**From:** Peter J. Hinck <[REDACTED]>  
**Sent:** Thursday, July 19, 2012 11:40 AM  
**To:** 'Fred Marinelli'  
**Cc:** Cory D. Anderson; Tina Pint; Al Trippel; Carlson, Erik (DNR); David Blaha; Houston Kempton; Paul Haby; John L. Adams; Jim Scott ([REDACTED])  
**Subject:** RE: Cat 1 stockpile pH

Site: Mine Site

Activity: GoldSim Task 2 QA

Issue: Cat 1 stockpile

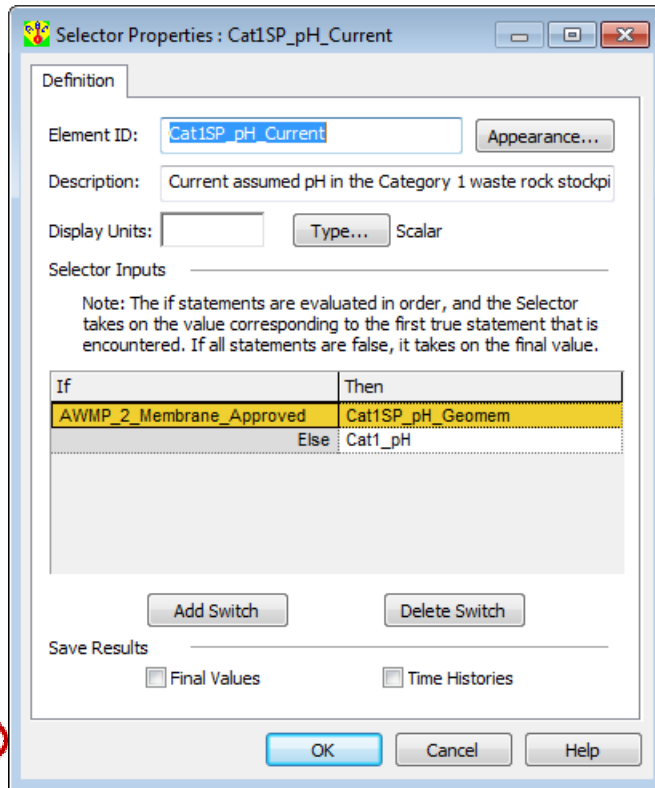
Model appears to be using a P50 pH = 7.25, which is appropriate for a soil cover.

Input tables indicate that the model should use P50 pH = 7.95 for a geomembrane cover.

We believe the programming issue is in Element ID: Cat1SP\_pH\_Current.

Cat 1 pH affects numerous geochemical calculations involving the concentration of constituents in Cat 1 seepage.

You are correct that the model files submitted 2 weeks ago did not have the pH of the Category 1 Waste Rock Stockpile modeled correctly. This was the result of some testing that I was doing, and I neglected to change the value back before submitting the models. See the screen shot below for the correct (and current) modeling of the referenced element (Cat1SP\_pH\_Current), with the line that needs to change circled (I believe the version you have just lists this as "false").

Erik et al., this error was corrected prior to performing the modeling runs used in the AWMP Version 2, submitted last week. The full package of model results posted to the project website, however, were from a modeling run that included this error. The effect of this change on the ultimate concentrations in the Partridge River and groundwater is minimal, but it does represent an inconsistency in the model. Please advise if you'd like us to update the posted results spreadsheets.
